Ogdensburg City School District

2023 Capital Outlay Project

Dome Sidewalk Replacement

Change Order Number: 1-02

Cost Proposal BC-02 from Contractor dated 7/25/23 Contract Drawings L220 and L320

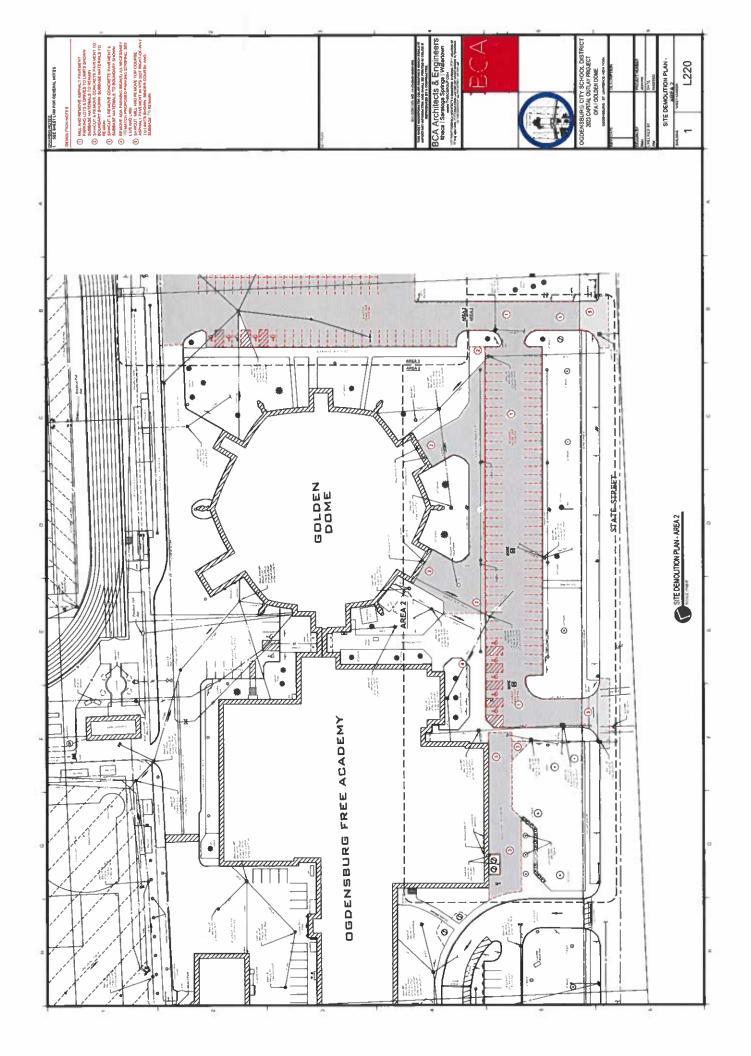
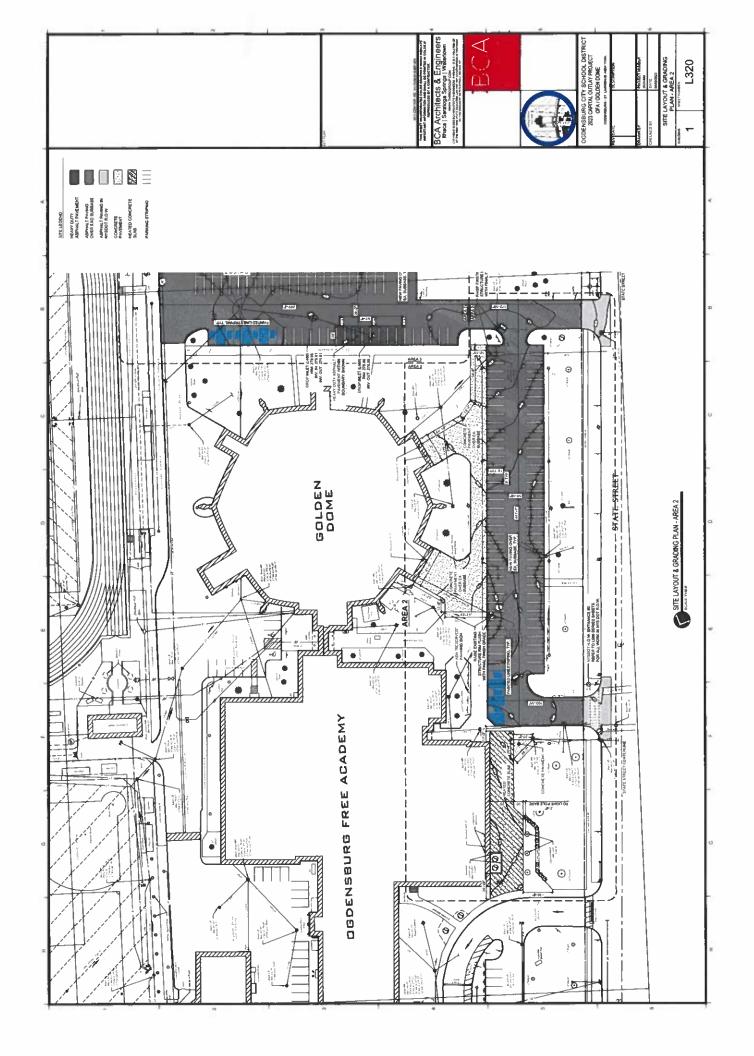
Add to provide all labor, materials, and equipment to replace raised section of existing concrete sidewalk from nearest expansion/construction joint in front of the Golden Dome in accordance with unit pricing as per the Form of Proposal for Contract No. 1 -General Construction.

Area 2: Adjacent to the left entrance into the Dome 1,225SF @ \$50/SF =\$61,250

Α	General Contractor
В	Under the Capital Outlay Project, existing sidewalks were scheduled to be replaced as per Contract Drawing L220 & L320.
С	Following demolition of sidewalk in front of the Golden Dome, the General Contractor discovered that the existing concrete scheduled to remain at the north end was several inches higher than the new sidewalk. The walk had been lifted / elevated as a result of winter frost action; and now presented a tripping hazard to pedestrians. As such, the General Contractor replaced an additional area of concrete sidewalk adjacent to the scheduled new sidewalk in accordance with the unit price provided on their form of proposal. Note that the Owner only received a single bid under Contract No. 1 -General Construction for the 2023 Capital Outlay Project.
D	Add to provide all labor, materials, and equipment to replace raised section of existing concrete sidewalk from nearest expansion/construction joint in front of the Golden Dome in accordance with unit pricing as per the Form of Proposal for Contract No. 1 - General Construction.
